Talcott Engineering DESIGN, PLLC

March 6, 2015

Re: Kozlowski Subdivision
Town Project No. 2015-04
S-B-L: 2-1-9
Job No. 14112-MTK

Please be advised that Talcott Engineering has prepared a revised subdivision plan set for the above referenced subdivision for the March 19th public hearing. Said plan set has been revised to address the following:

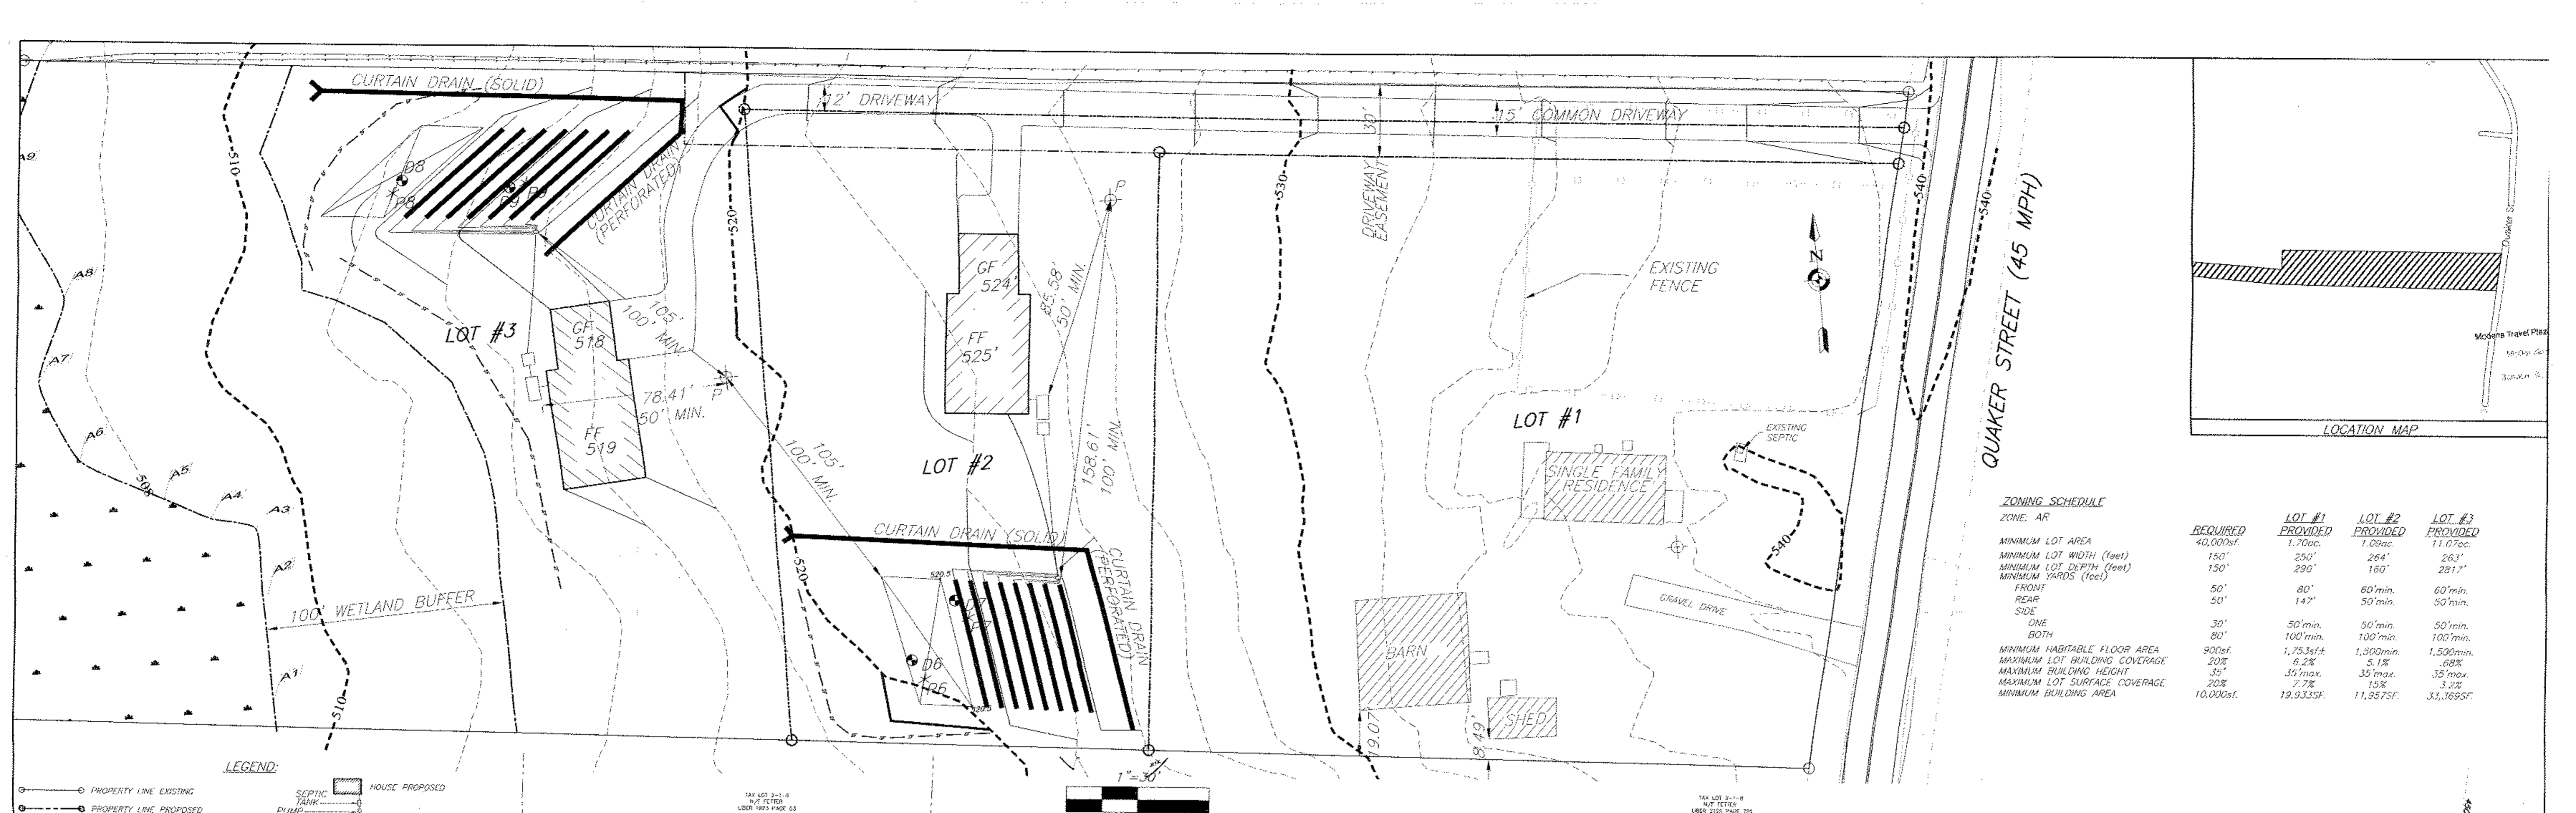
Patrick Hines – McGoey, Hauser & Edsall, P.C. Comments dated 2/12/15

1. The requested note has been added to plans.
2. Curtain drains have been added to the two proposed septic systems.
3. These plans have been forwarded to Joe Safioti, esq., for the common driveway and access agreement.
4. These plans have been forwarded to the Town Highway Superintendent comment driveway.
5. The existing septic system is shown based on field verification.
6. The owners have no intention of keeping domestic animals.
7. The appropriate DEC Wetland notes have been added to plans
